March 21, 2022
LR-N22-0022

Salem Generating Station Units 1
Renewed Facility Operating License No. DPR-70
NRC Docket No. 50-272

Subject: Response to Request for Additional Information Relief Request S1-I4R-210,
Alternative Examination of Welds

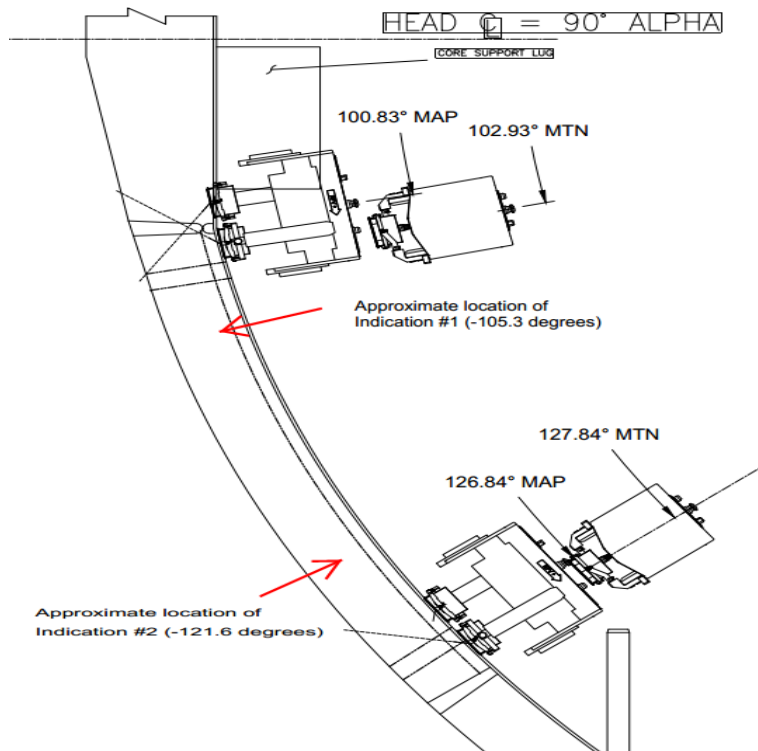
Section 1.8 of Attachment 1 states that the licensee detected two subsurface indications in meridional weld 1-RPV-1043E, at 150°, lower head, during this examination. The licensee evaluated each recordable flaw for acceptance as shown in Tables 1.8-3, 1.8-4, and 1.8-5 of Attachment 1.

(1) Provide additional information (e.g., a sketch) regarding the approximate locations of the two indications with respect to the inside diameter surface of the weld and to each other, including cladding thickness. (2) Discuss whether these two indications are located in the vicinity of each other such that they should be combined and considered as a single indication. (3) Section 1.8 of Attachment 1 states that the indication was detected during this examination. However, it is not clear whether this is the first time the indication was detected. State whether the indication was detected the very first time during this examination. If applicable, discuss whether the licensee reviewed the results from previous examinations (a look-back) to determine whether this indication has grown and provide a discussion of the results of that review. (4) Discuss whether these two indications will be examined in future ISI intervals; if not, provide justification.

(1) .

- (2) These are two separate indications. Both are located circumferentially at approximately the same degree location however they are separated in the vertical dimension by approximately 16 degrees. Note: since the head is spherical the vertical and horizontal dimensions are both specified in degrees, Alpha and Theta respectively.

Theta Location	Alpha Location	Flaw Depth (excluding clad)
Indication #1	207.96° - 208.62°	-105.3°	1.769" - 2.005"
Indication #2	207.05° - 208.11°	-121.6°	2.142" - 2.332"

As a result these two indications are separated by approximately 16° (approximately 25") in the vertical (Alpha) dimension.
